Access Compliance Report

Public Rights-of-Way

(Curb Ramps)

Intersection ID: 5889	Main Street: UNIVERSITY_CITY_BV	Cross Street: SUTHER_RD	Location:	N
ADA ID: 87677E4A8DFF	Ramp Type: Perp	Initial Pass/Fail: Fail	Overall Compliance: No	Severity Score: 25

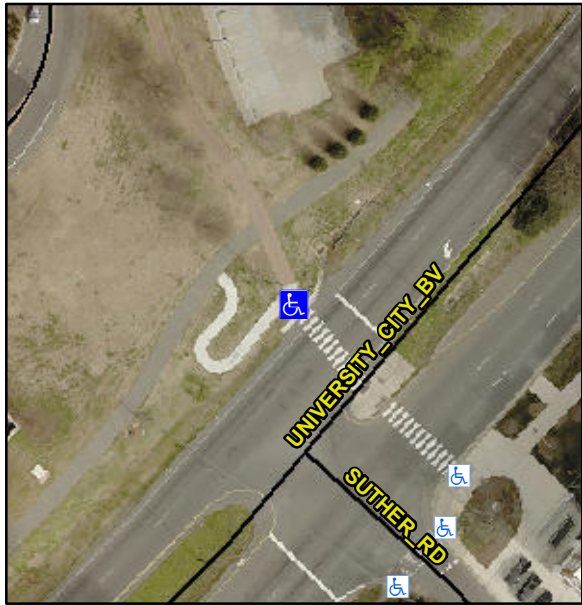
Codes/Mitigation Info/Possible Solution			Field Measurements/Component Compliance					
	Possible Solutions:		Compliance	Description	Data	Compliance	Description	Data
	Remove & Replace Entire Ramp.		N/A	Ramp Length (in)	90.0	No	Ramp Slope (%)	20.0
			Yes	Ramp Width (in)	96.0	Yes	Ramp XSlope (%)	1.9
			N/A	Flare Type LT	N/A	N/A	Flare Type RT	N/A
			N/A	Flare Slope LT (%)	N/A	N/A	Flare Slope RT (%)	N/A
			N/A	Flare Traversable LT?	N/A	N/A	Flare Traversable RT?	N/A
			N/A	Landing Length (in)	N/A	N/A	DWS Provided?	N/A
			N/A	Landing Width (in)	N/A	N/A	DWS Contrast?	N/A
			N/A	Landing Slope (%)	N/A	N/A	DWS Length (in)	N/A
			N/A	Landing X Slope (%)	N/A	N/A	DWS Full Width?	N/A
Surveyor Notes:			N/A	Landing Curb? (Y/N)	N/A	N/A	DWS Offset (in)	N/A
N/A			N/A	Shared Landing?	N/A			
PROW/ADA:			N/A	Gutter Ponding?	N/A	N/A	Gutter Slope (%)	N/A
Not Found, R304.2.2			N/A	Gutter Lip Ht (in)	N/A	N/A	Gutter X Slope (%)	N/A

N/A	Painted X Walk1?	Yes	N/A	Painted X Walk2?	N/A
				X Walk 1 Direction	To SE		X Walk 2 Direction	N/A
			N/A	X Walk 1 Width (in)	121.0	N/A	X Walk 2 Width (in)	N/A
				X Walk 1 Slope (%)	7.6		X Walk 2 Slope (%)	N/A
				X Walk 1 X Slope (%)	0.7		X Walk 2 X Slope (%)	N/A
			N/A	Ramp inside XWalk1?	Yes	N/A	Ramp inside XWalk2?	N/A
				Road Slope (%)	N/A	N/A	Clear Space?	N/A
				Road X Slope (%)	N/A	N/A	Clear Space to XWalk (in)	N/A
			N/A	Any Obstructions?	N/A	N/A	Storm Grate/Utility Hazard?	N/A
				Obstruction Type			Storm Grate/Utility Type	
					N/A			N/A
						Yes	Surface Condition? (G/P)	Good
Total Cost:		\$ 1850.00
